### Issue: Ball Joint Replacement and Memory Steer on RWD Ford F Series and E Series

<b>Publication:</b>	TSB-20-018-01-01-E	<b>Product</b>	Ball Joints	<b>Date</b>	May 2020
<b>Part Number(s)</b>	Original Grade: GK80028, GK80197, GK80196, GK80027 Supreme: MK80028, MK80197, MK80196, MK80027, MS40060 TTX: TXK80028, TXK80197, TXK80196, TXK80027

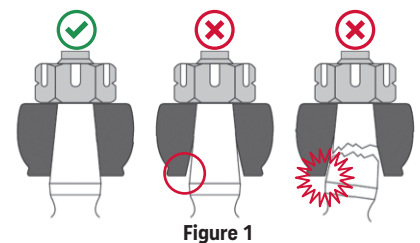
After installing ball joints with the following part numbers (*E-Series – Upper- GK80028/GK80196/MK80028/MK80196/TXK80028/TXK80196 and Lower- GK80197/MK80197/TXK80197*) or (*F-Series – Upper- GK80028/MK80028/TXK80028 and Lower- GK80027/MK80027/TXK80027*) on RWD Ford E Series vans or F Series Super Duty trucks, the vehicle operator may encounter a “memory steer” condition. This may be represented by poor or incomplete steering wheel return, a “tight” feel while centered and or increased difficulty rotating the steering knuckle. This may be the result of ball joint binding and reduced range of motion due to improper installation. Improper installation can reduce the performance and service life of the part.

**To successfully install the ball joints and prevent a “memory steer” condition, it is imperative to adhere to the following:**

- Discard old ball joint nuts and bolts. Do not reuse hardware. Ensure to renew hardware.
- Ensure the ball joint is even and square on the proper install axis. Correct seating and alignment are critical to part life longevity. This may require more than one reset of the tool position during install.
- Do not use a heat source to aid in removal. This can warp/distort or otherwise damage the knuckle bore or spindle ears.
- Do not use a hammer or apply blunt force to aid in removal or installation. This can warp/distort or otherwise damage the knuckle bore and or ball joint.
- If adjustable camber sleeve has been installed, mark position before removal.
- Only use a calibrated torque wrench for final fastening.
